Re: Overlook Terrace Site Plan Application and  
Referral from Town Board of Proposed Zoning Text Amendments  
119 Oregon Road, SBL 23.11-1-12 ("Property")

**Subject:** Traffic Comment Responses – Overlook Terrace  
Town of Cortlandt, New York

RE: **PLANNING BOARD CASE 2021-01**  
**“Overlook Terrace – 119 Oregon Road”**

Figure No. CP-1

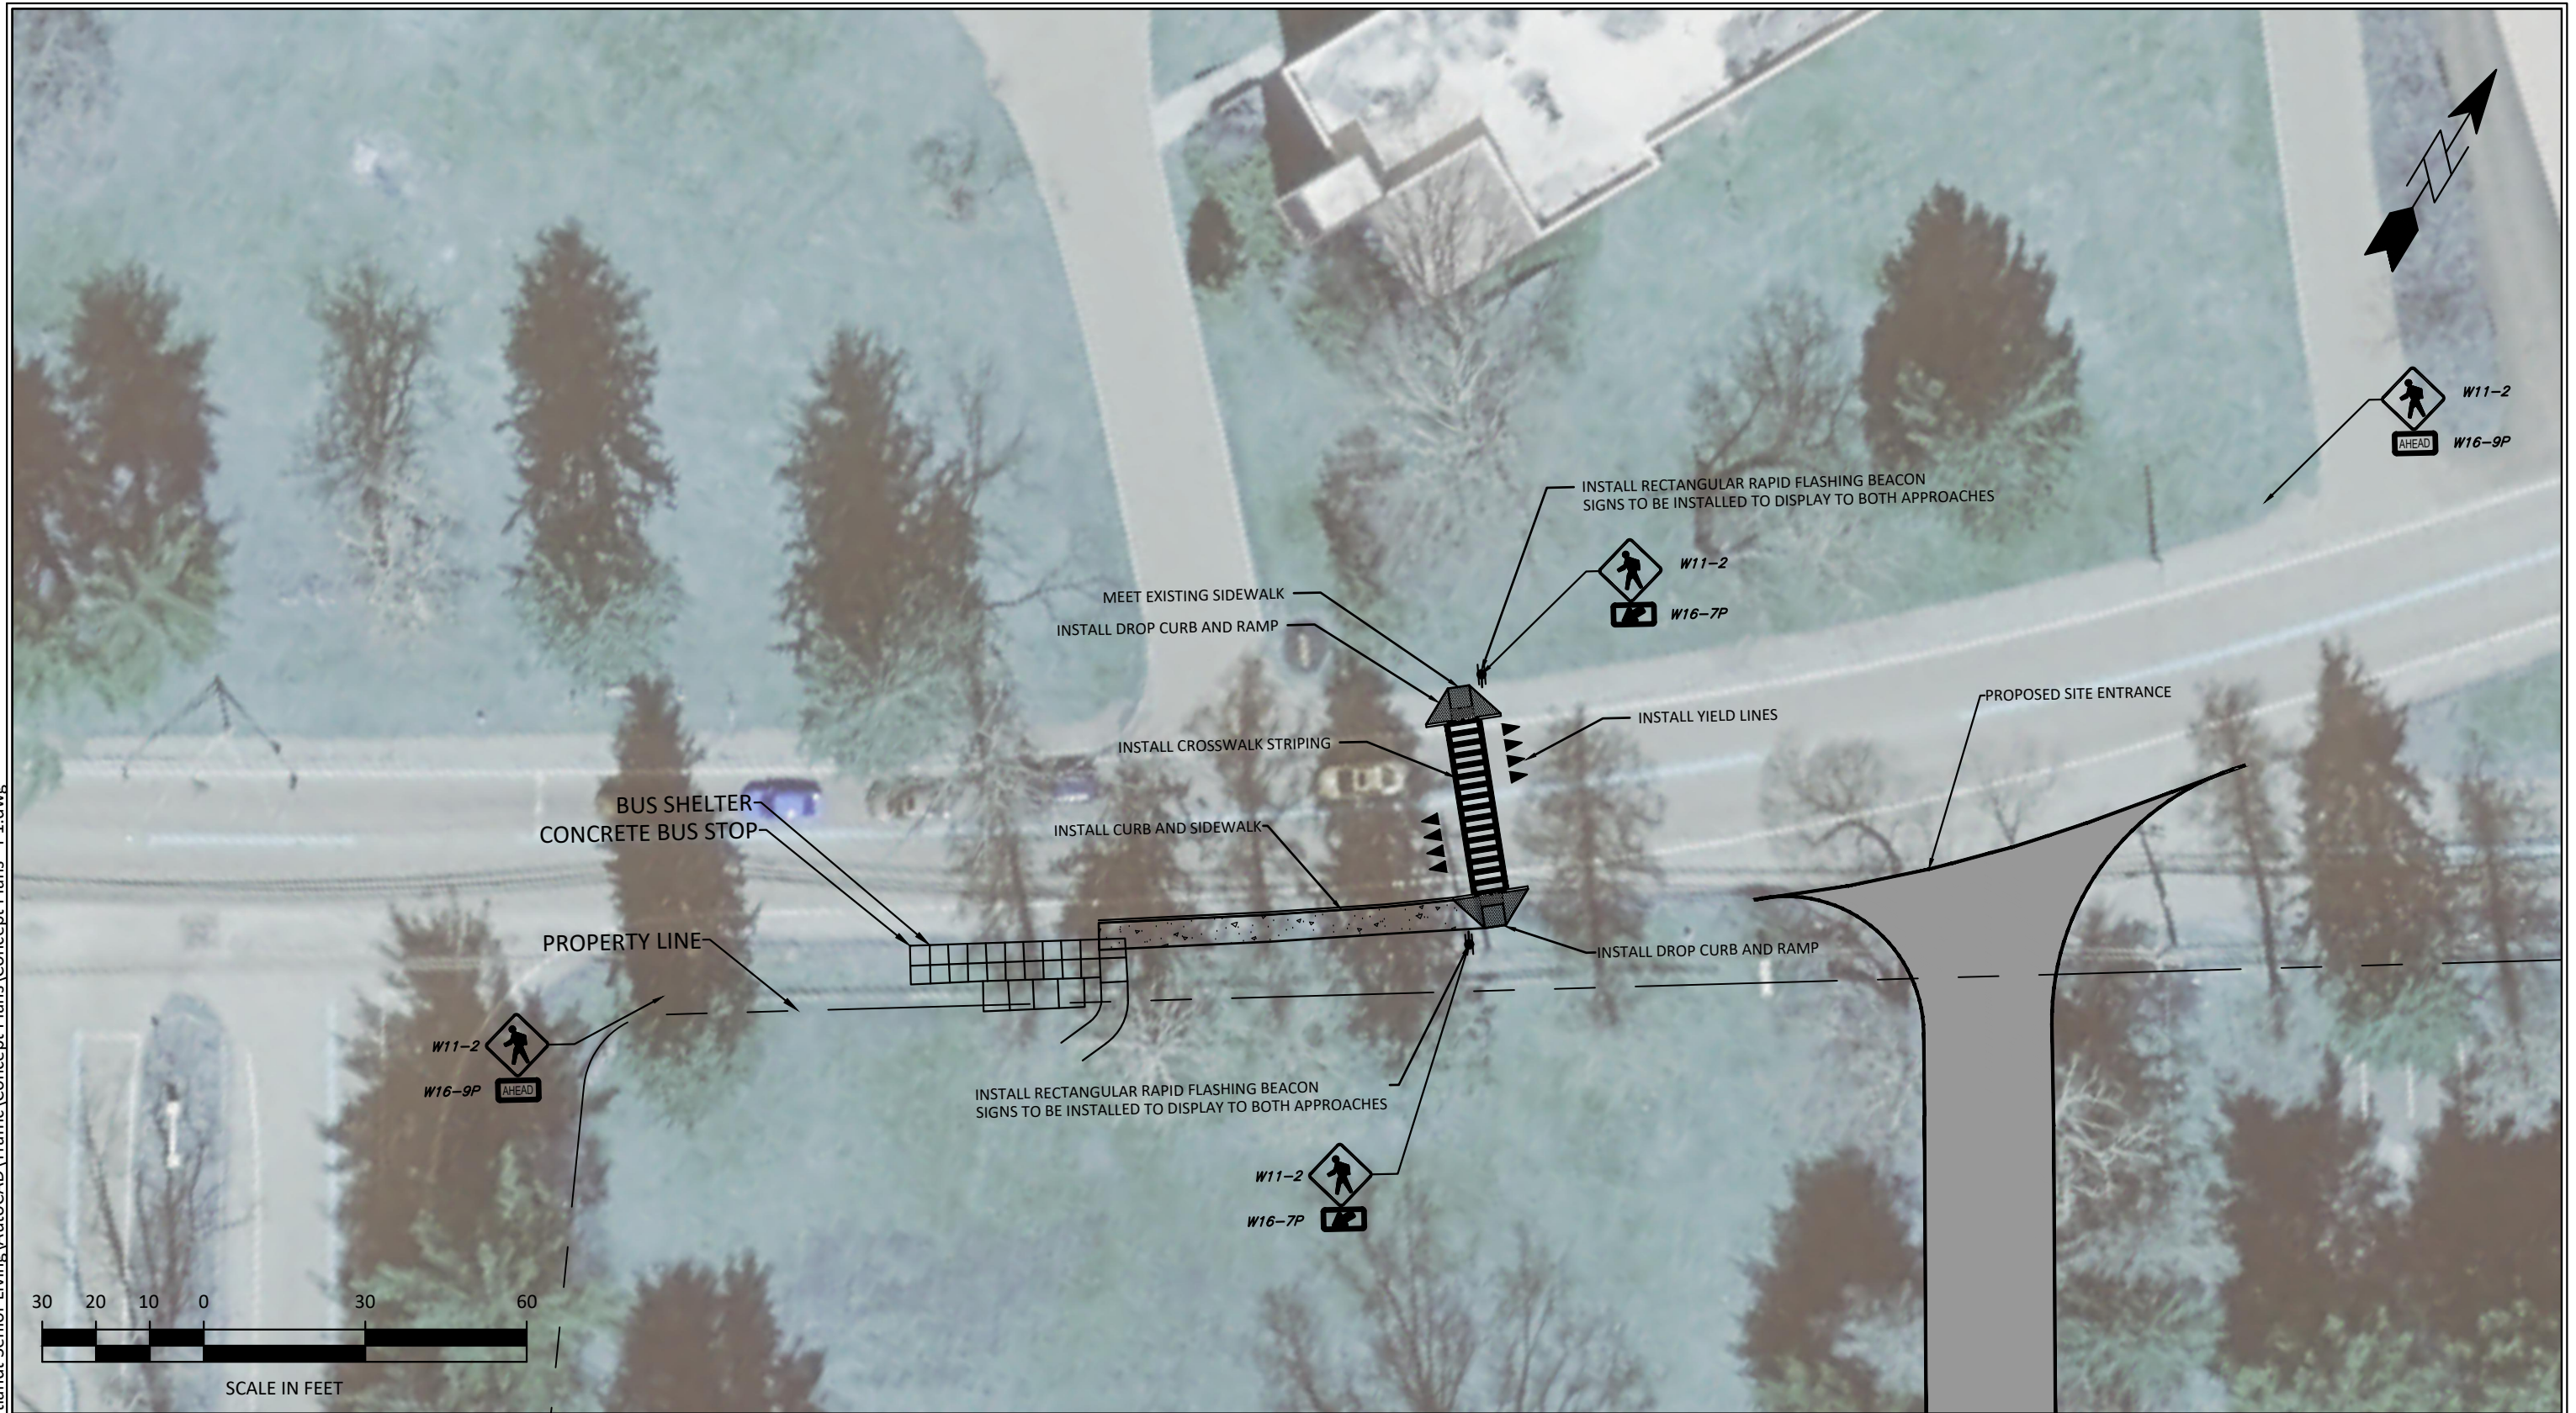
Concept Plan CP-1 – Proposed Rapid Rectangular Flashing Beacon (RRFB) pedestrian crossing to be installed at proposed site driveway intersection. This improvement would be implemented by the Applicant and would provide a much safer pedestrian crossing for both existing and project-generated pedestrian traffic in the area. The pedestrian crossing sign would illuminate with a flashing beacon when pedestrians were crossing to alert drivers to stop and allow pedestrians to safely cross. This improvement would cost approximately \$20,000 to \$30,000.

Figure No. CP-2  
T1

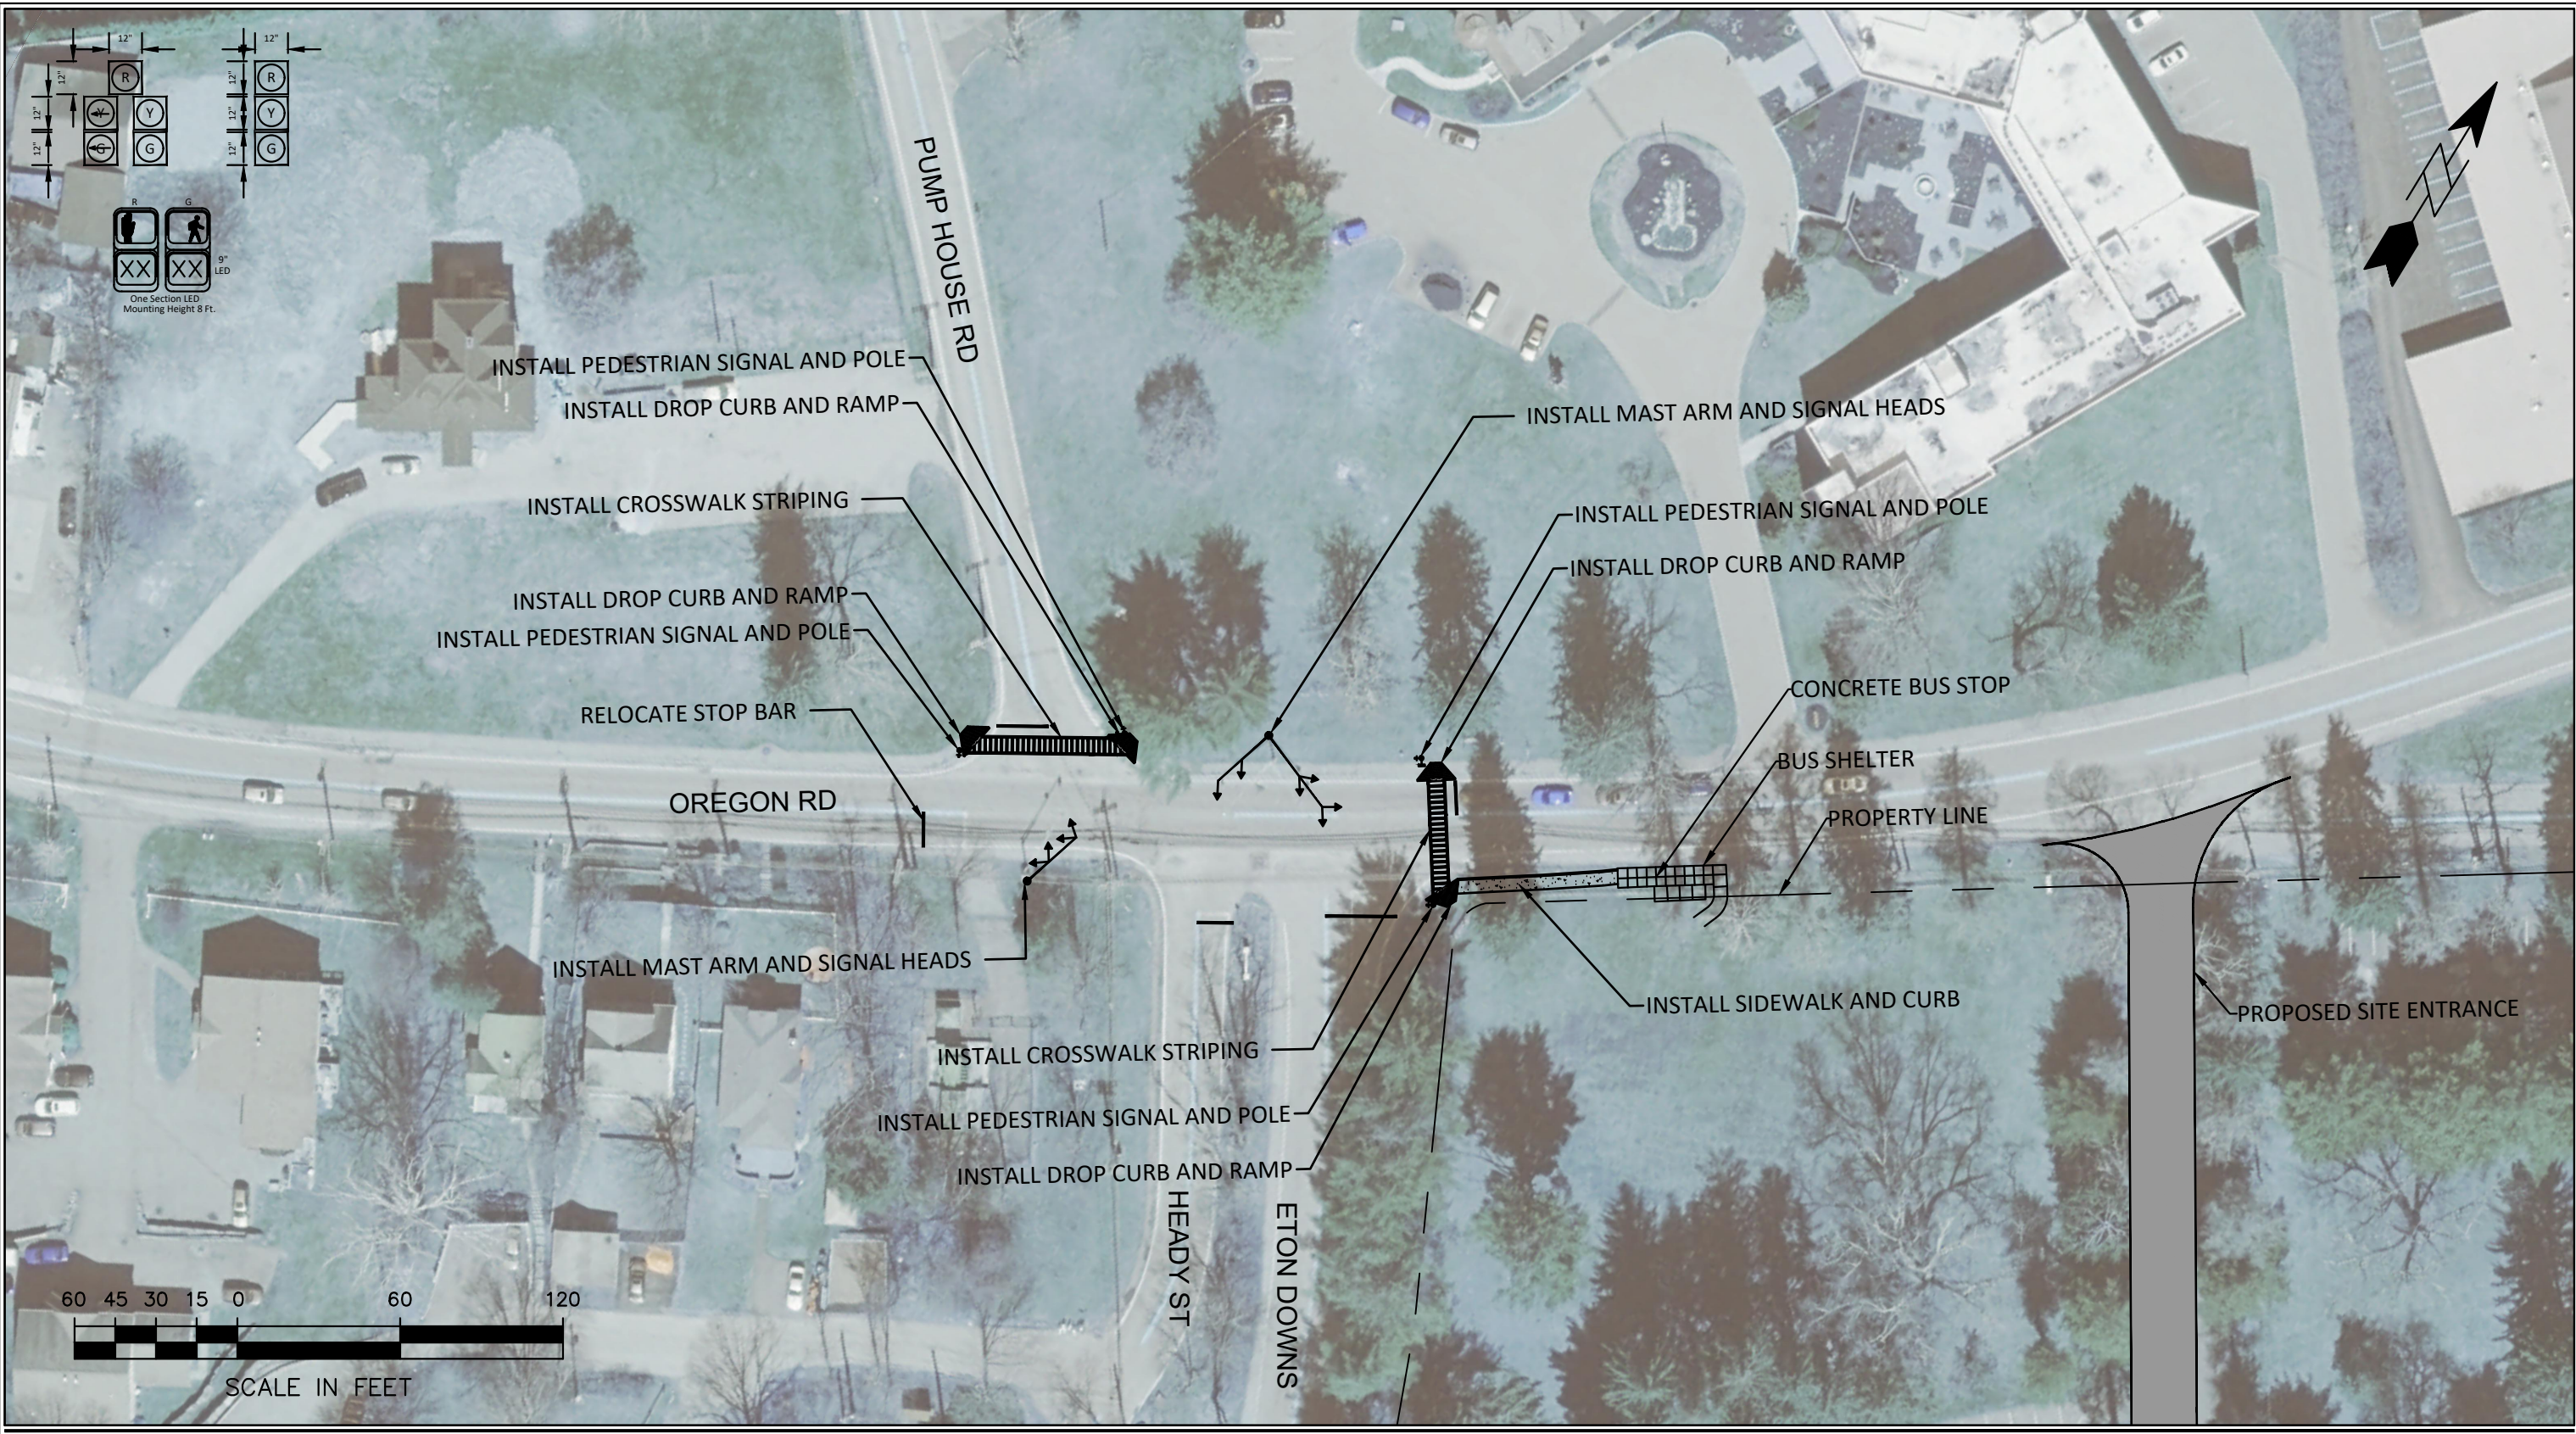
Concept Plan CP-2 – Proposed pedestrian crossings on the eastern leg of Oregon Road and the Pumphouse Road leg of the signalized intersection. This improvement would include a new traffic signal system to be installed with associated pedestrian traffic signals. This improvement would cost approximately \$500,000.

Figure No. CP-3

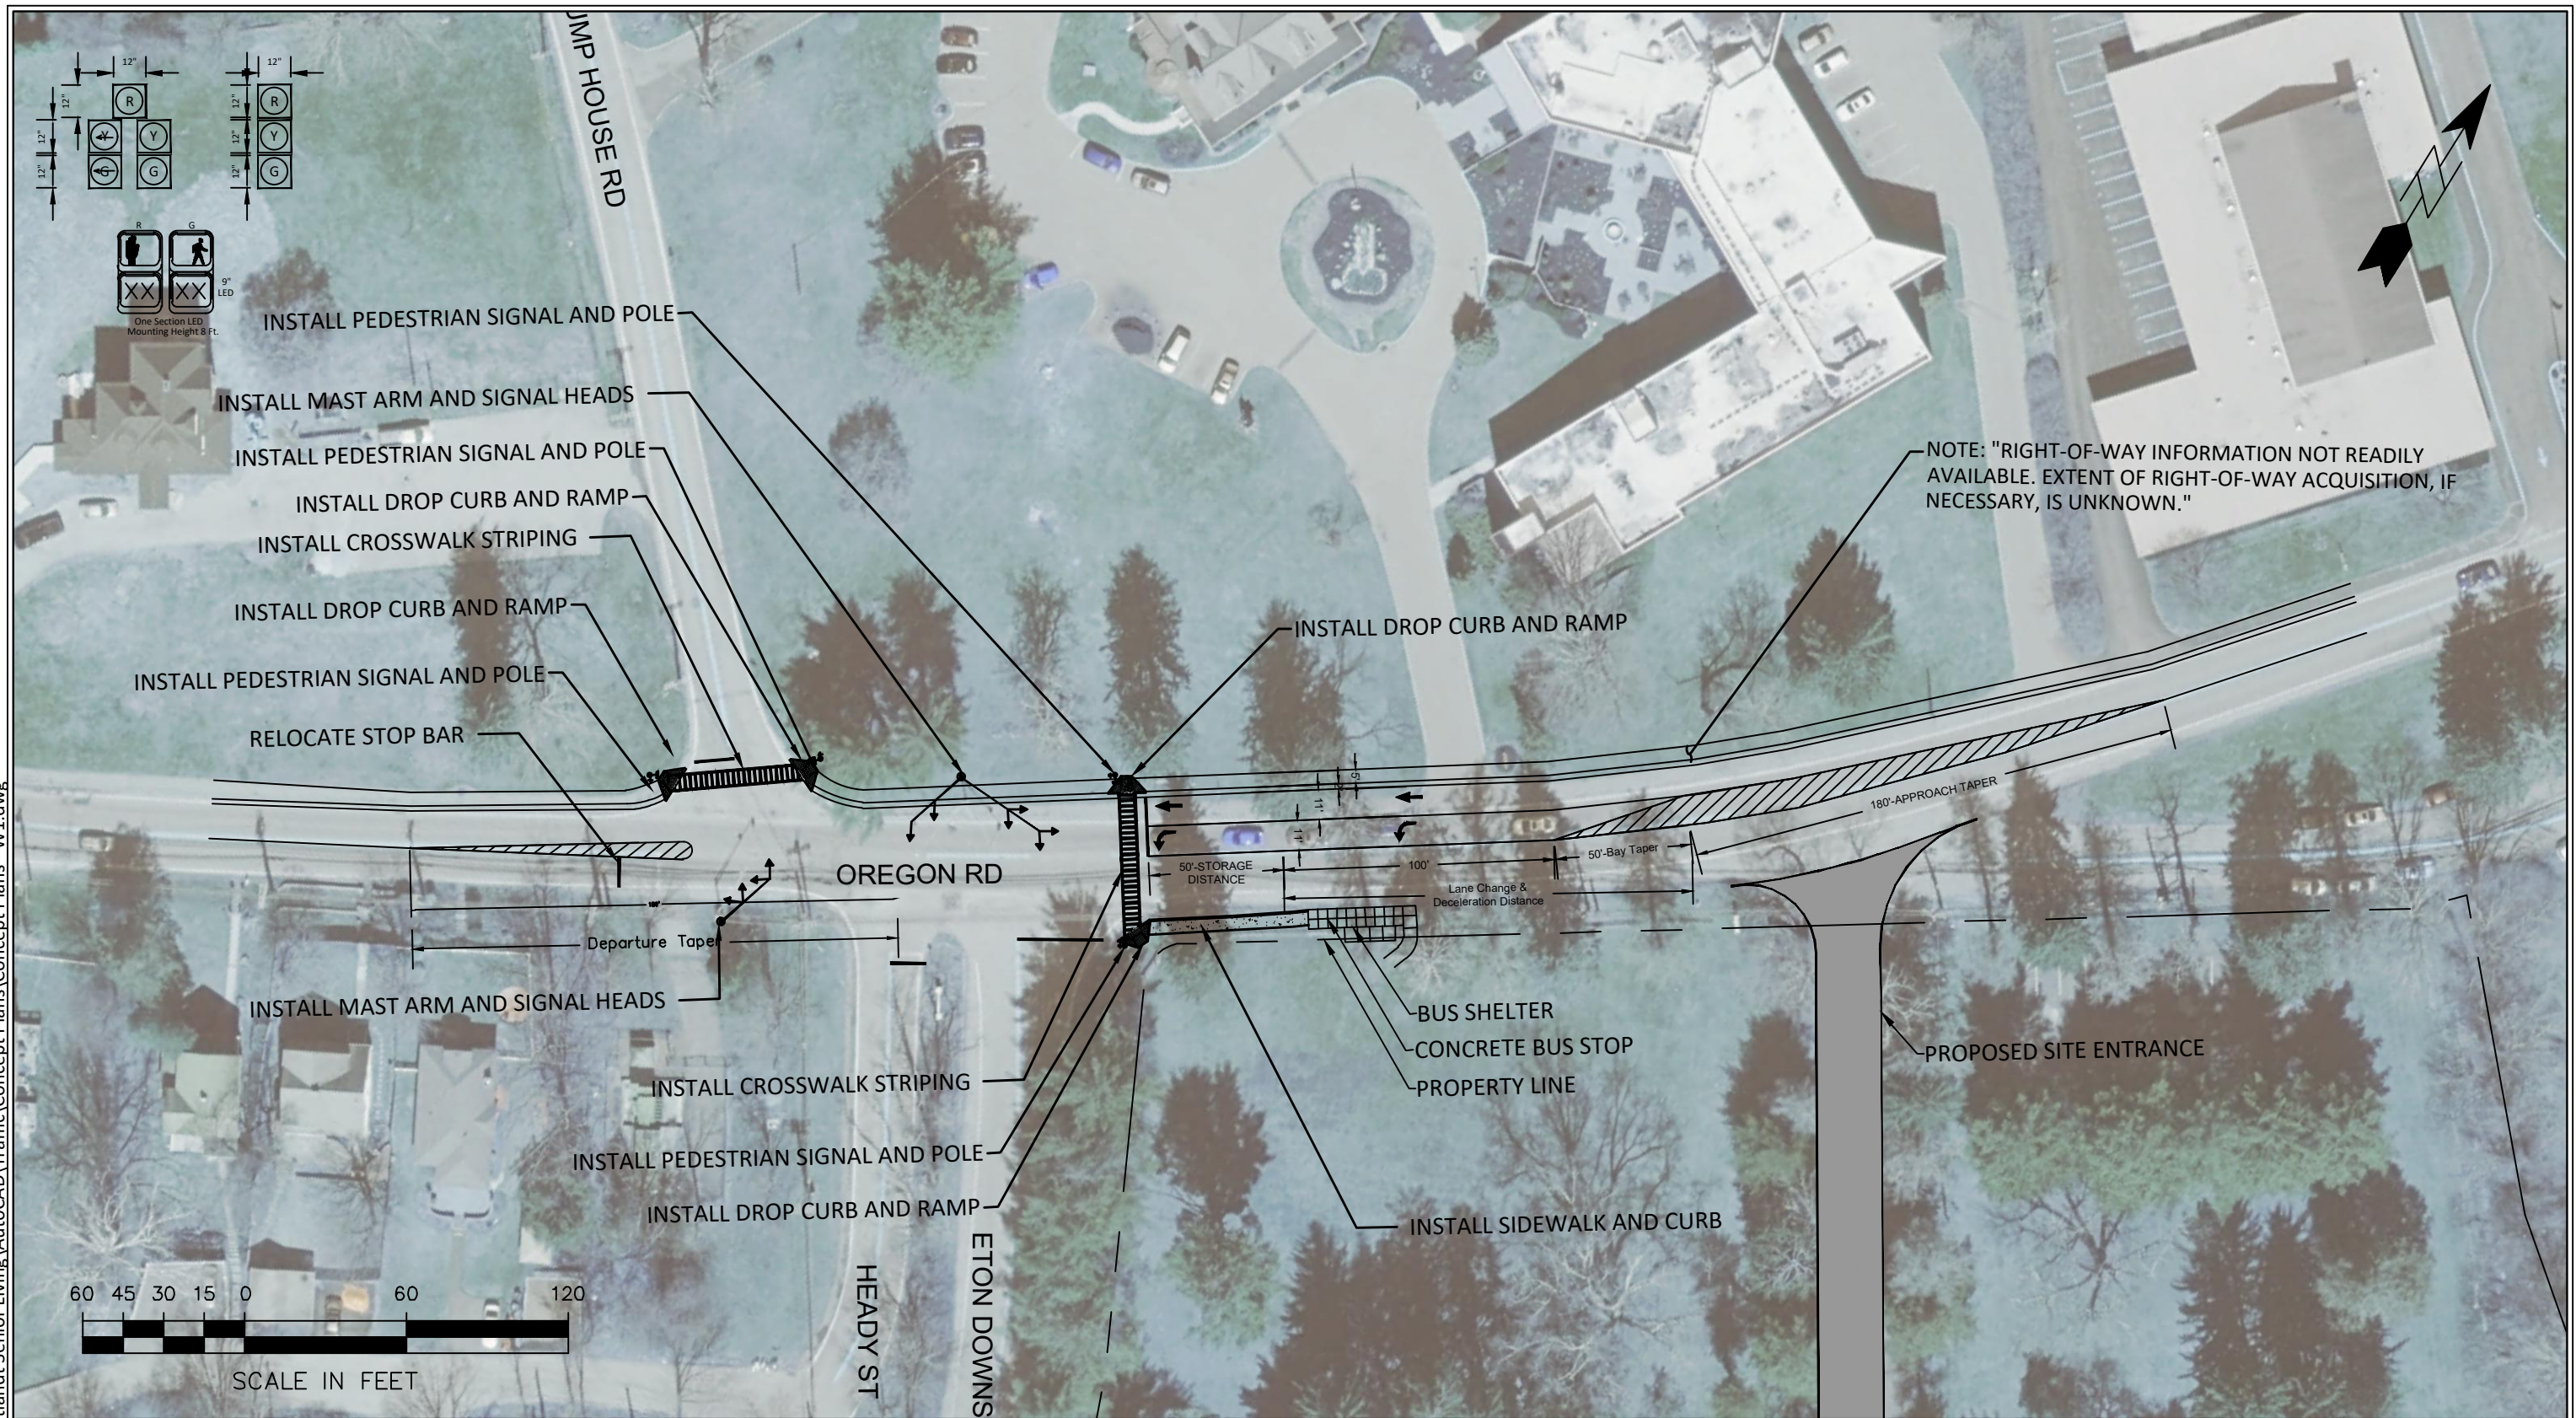
Concept Plan CP-3 – This would be the same improvement as CP-2, with the exception that a dedicated left-turn lane would be provided along the westbound approach of Oregon Road. This improvement would cost approximately \$750,000. It is noted that the extent of Right-of-Way availability for this improvement is unknown.
